Richard Dwyer <richard.dwyer@nwb-oen.ca>

ECCC Eureka HAWS Regulatory Project - Planned site activities for the Landfarm project this fiscal year (8BC-EUR2131)

Karén Kharatyan < karen.kharatyan@nwb-oen.ca>

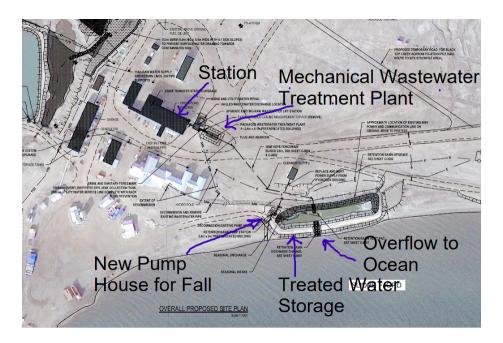
6. From my understanding, upon completion of the new Wastewater Treatment Plant (WWTP) the sewage lagoon will become a "Wastewater Retention Pond" for treated sewage discharge from WWTP, correct or not? If this is the case, will the Final Discharge Point be

after the Wastewater Retention Pond" or ECCC planning to discharge treated sewage directly from WWTP as well?

Correct. Treated sewage or effluent from the new wastewater treatment plant will be piped to the retention pond, which is then discharged into the Slidre Fjord (i.e., the final discharge point is from the retention pond into the Slidre Fjord). When discharging from the retention pond into the ocean, two methods will be applied:

- In the summer: Retention pond will be discharge via an open channel roughly 10
 metres long between the retention pond and the ocean. This is effectively an
 overflow channel.
- In the Fall: Retention pond is discharged using a 25 metre long, 75 mm diameter hose and pump which runs from the retention pond pumphouse to the ocean

A figure showing the relative location for the treatment plant and the storage cell are show below.

A figure showing a cross section of the overflow channel showing rip rap and geotextile is given below:
